ADDENDUM NUMBER ONE

DUPONT PUMP STATION AND BASIN IMPROVEMENTS - PHASE 2 W-12-026-202

CITY OF CHATTANOOGA, TENNESSEE

MD-5

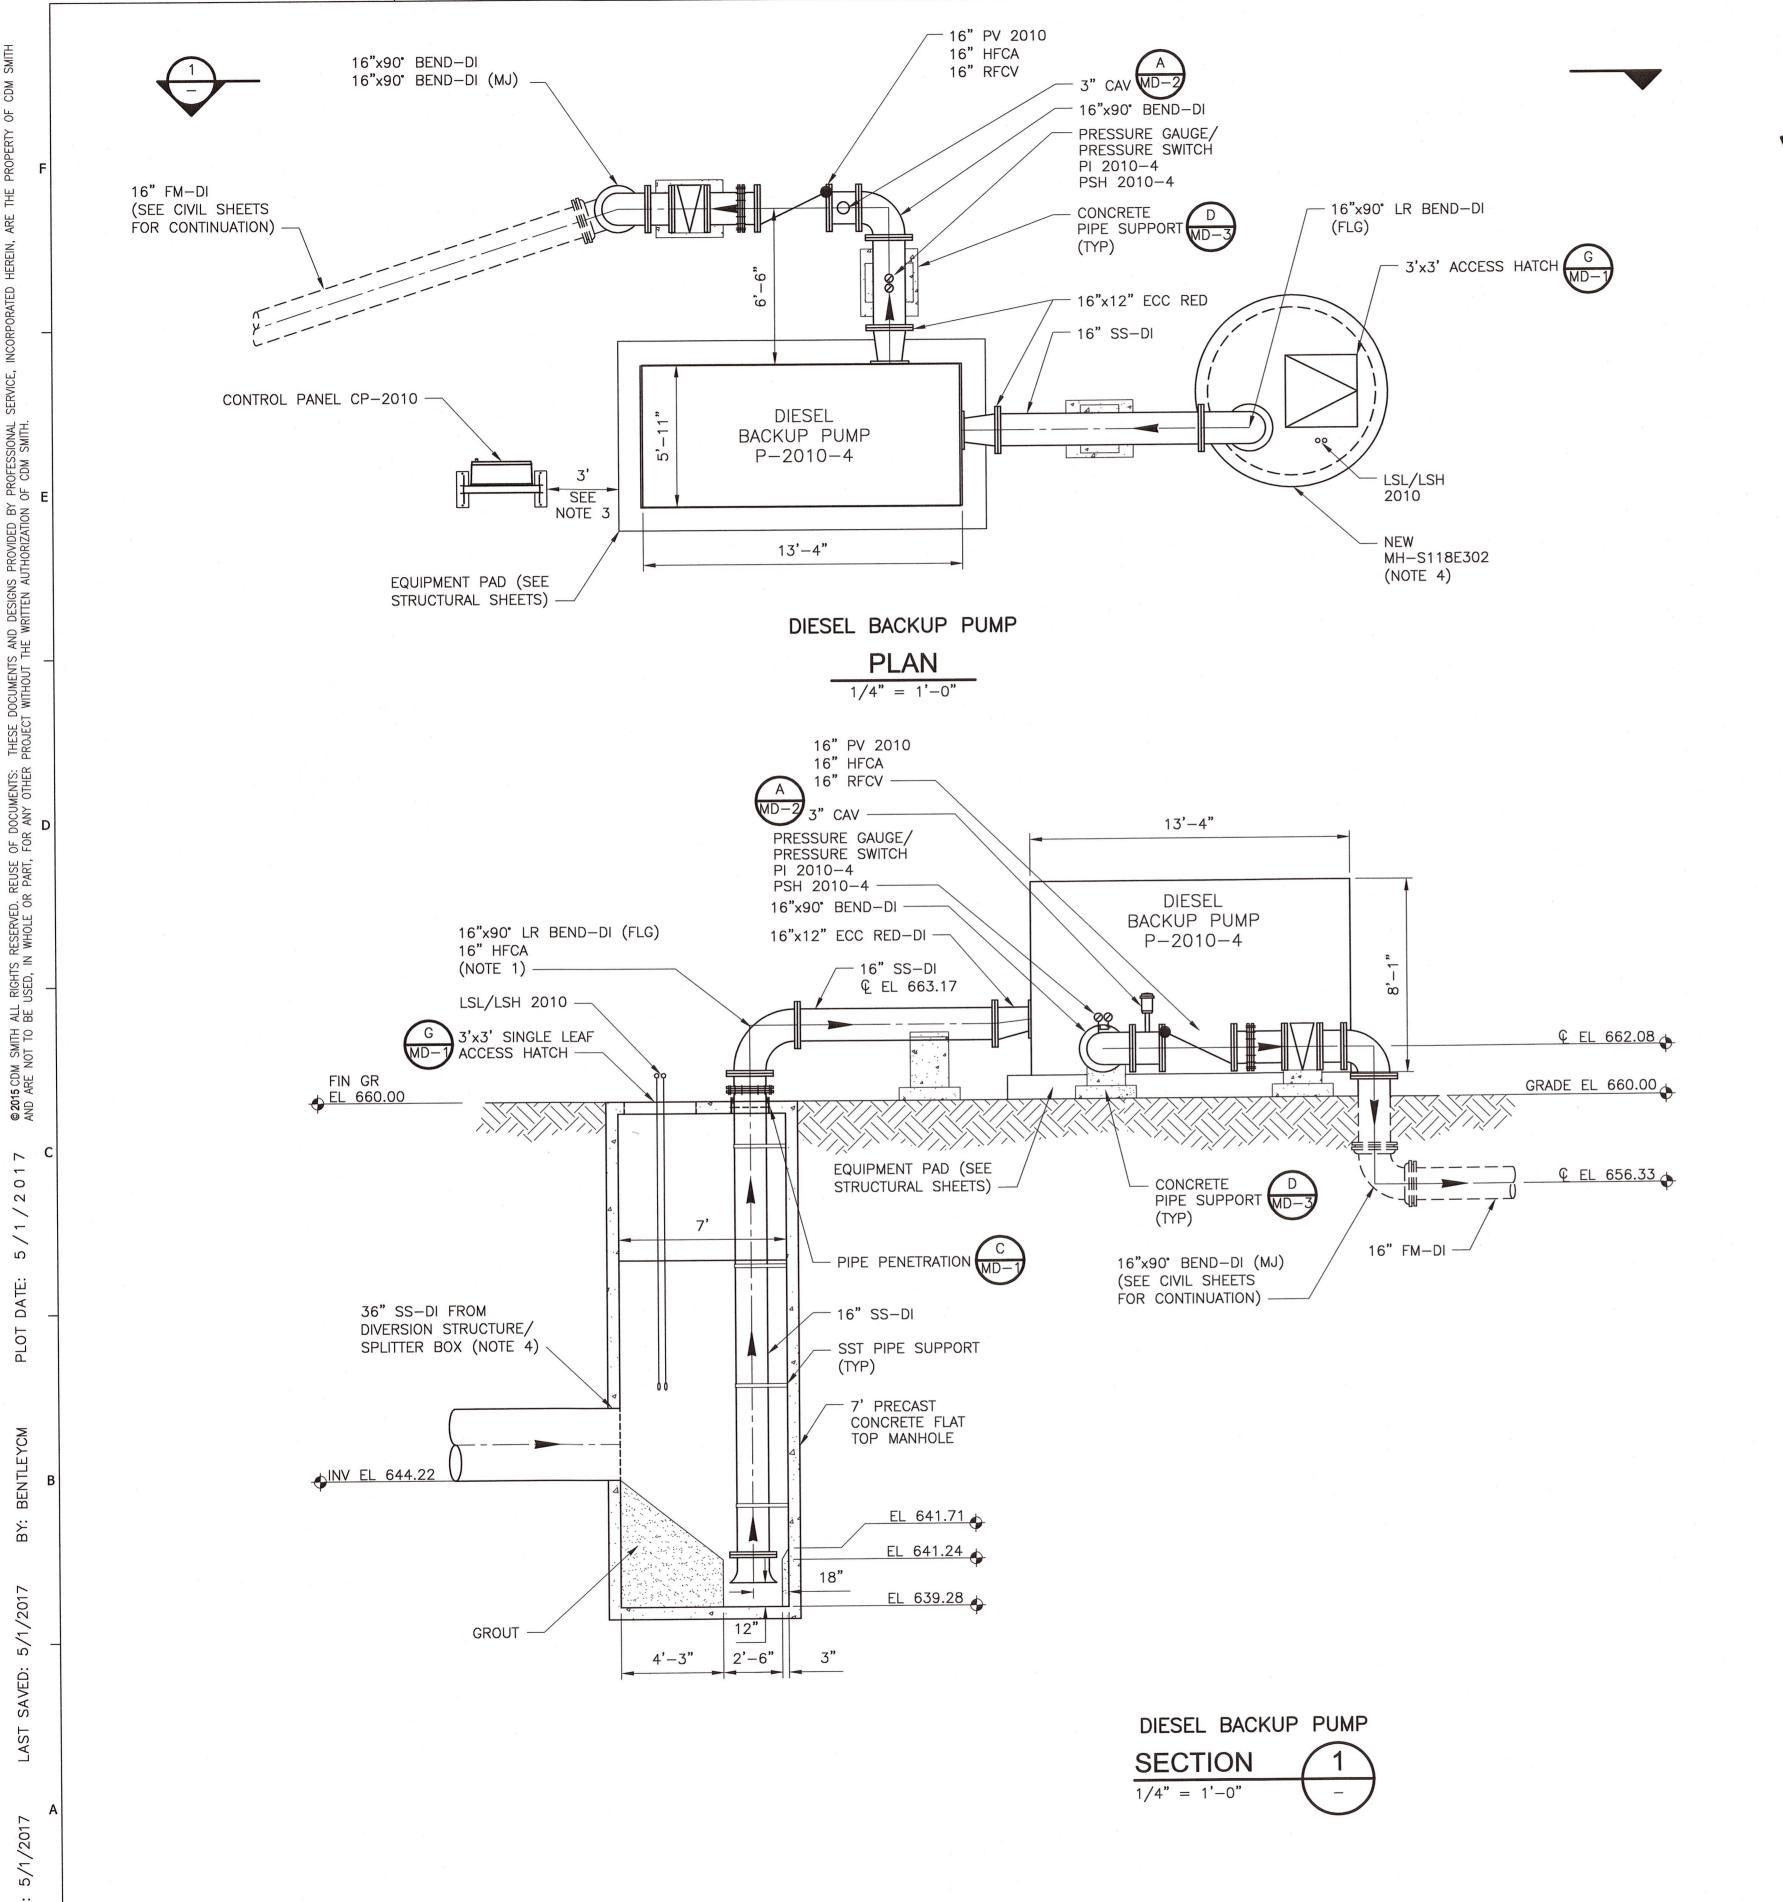
• The latest version of Drawing MD-5 was not included in the set left with the City. An updated drawing is attached. The only change is inclusion of an air valve on the discharge piping.
